# UNITED STATES PATENT AND TRADEMARK OFFICE

APPLICATION NO.	FILING DATE	FIRST NAMED INVENTOR	ATTORNEY DOCKET NO.	CONFIRMATION NO.
10/042,740	01/16/2002	George Krikorian	50064	3485

## Office Action Summary

## DETAILED ACTION

**Fig. 1**

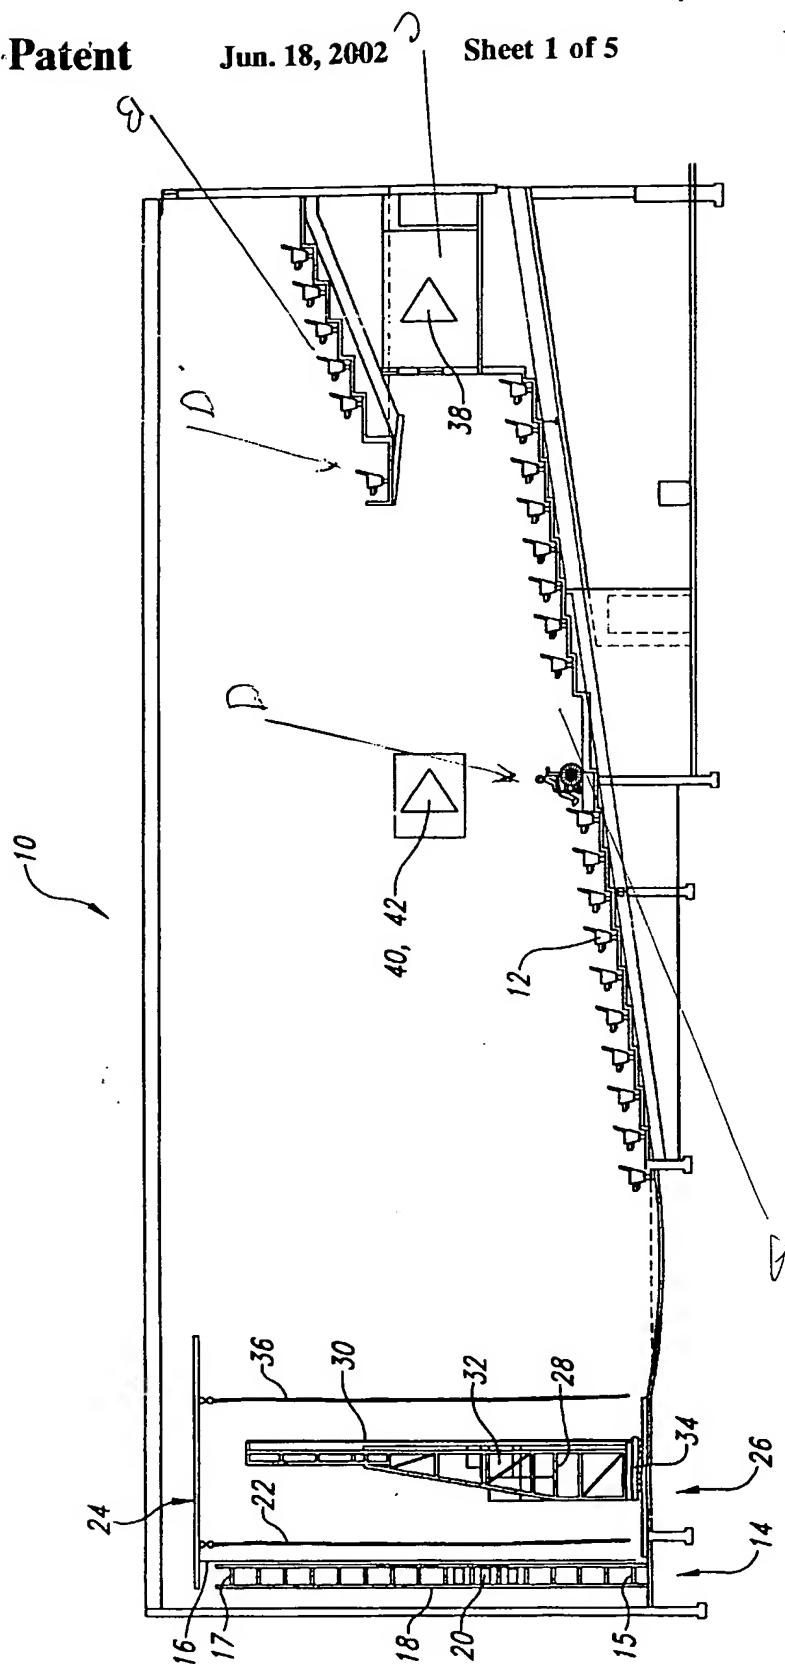
In regard to claim 11: Runge discloses the claimed invention Fig. 1, column 2, line 44-67, a plurality of multiplex theater 10 having six theaters 12, 14, 16, 18, 20, 22 and 14, each floor having a separate exit and entrance 12a and 12g, except having upper and lower seating level and middle level for motion picture projector, having separate mezzanine for upper and lower seating. Graves teaches Fig. 1, column 2, line 38-40, a theater 10 including lower seating level A (see attachment) and upper seating level B (see attachment) and a middle level C (see attachment) for use of a motion picture projection camera, having separate mezzanine and for

lower and upper seating. It would have been obvious to one of ordinary skill in the art at the time of invention was made to modify each theater of Runge's invention to have three levels with upper and lower seating and mezzanine and middle level for projection in order to construct two distinct seating levels which separated from projector level.

In regard to claim 13: Runge discloses the claimed except having each segregated level having seating for disabled other than front of the theater. Graves teaches Fig. 1, each segregated seating level A and B has seating D (see attachment) and D' (see attachment) for disabled patrons at areas other than only at the very front of the theater 10. It would have been obvious to one of ordinary skill in the art at the time of invention was made to provide each level with disabled seating area other than front of theater in order to have better viewing position of the screen for disabled person.
